LETTER REPORT SITE ASSESSMENT ADDENDUM 3 UNDERGROUND STORAGE TANKS
681 AND 682 NAS PENSACOLA FL
4/23/2002
TETRA TECH

Subject: Site Assessment Report Addendum No. 3, Underground Storage Tanks 681 and 682,
U.S. Naval Air Station Pensacola, Pensacola, Florida
FDEP #179202973

Tetra Tech NUS, Inc. (TTNUS) is pleased to submit this Site Assessment Report (SAR) Addendum No.3 for Underground Storage Tanks (USTs) 681 and 682 located at Naval Air Station Pensacola (NASP), Pensacola, Florida. This SAR Addendum No. 3 has been prepared for the U.S. Navy Southern Division Naval Facilities Engineering Command under Contract Task Order 0098, for the Comprehensive Long-term Environmental Action Navy (CLEAN) Contract Number N62467-94-D-0888.

CONTRACT NO.	0231
APPROVED BY	DATE
APPROVED BY	DATE
DRAWING NO.	FIGURE 2
REV.	0

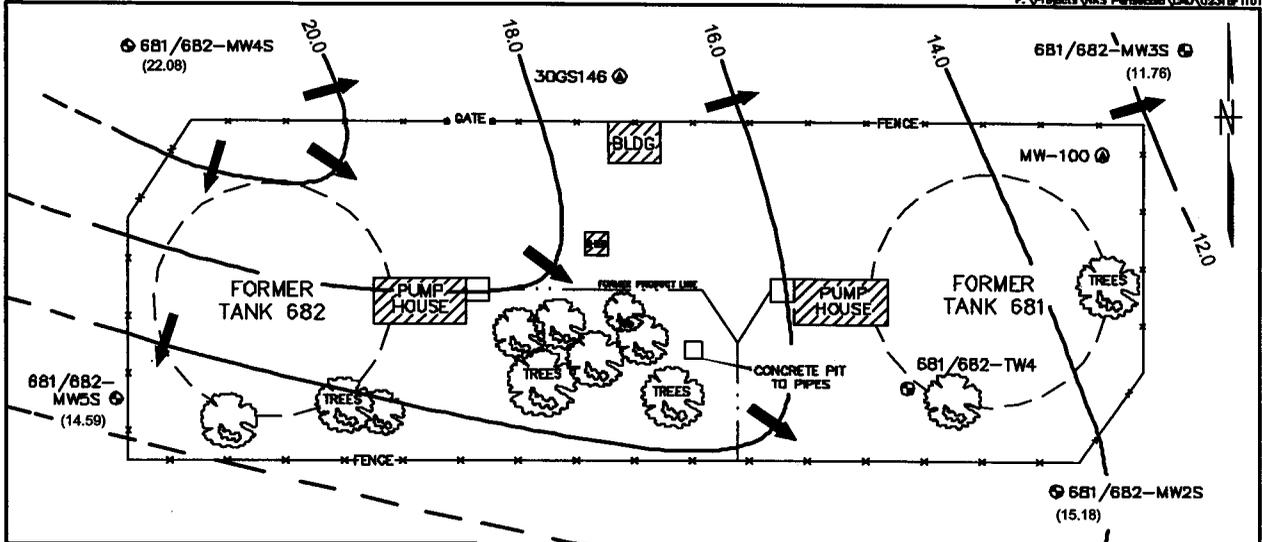
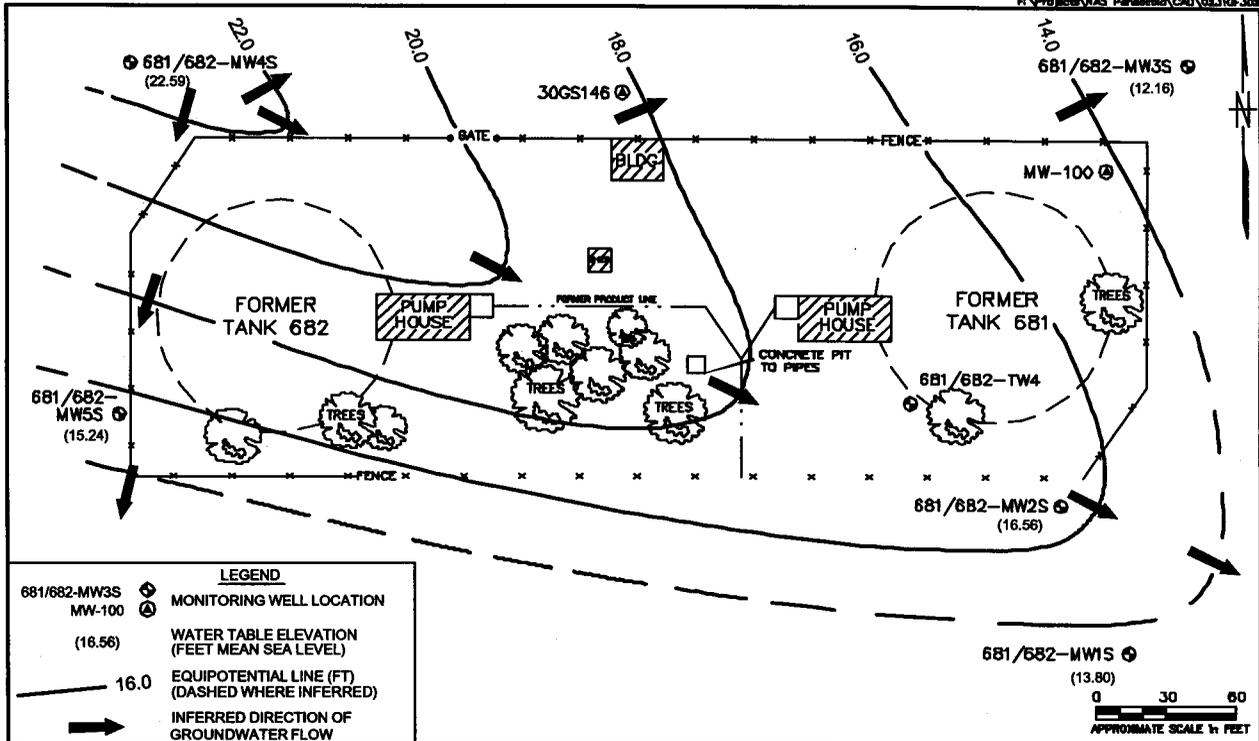
3. *Two complete rounds of water level elevation surveys at least one month apart should be completed to establish site flow conditions, and to aid in determining which monitoring wells should be included in future monitoring events.*

Two complete rounds of groundwater level elevation surveys were conducted on November 27, 2001 and March 12, 2002. The results are included in Attachment D and presented graphically on Figure 2 and 3; Attachment B. Based on the results the groundwater flow is toward the southeast.
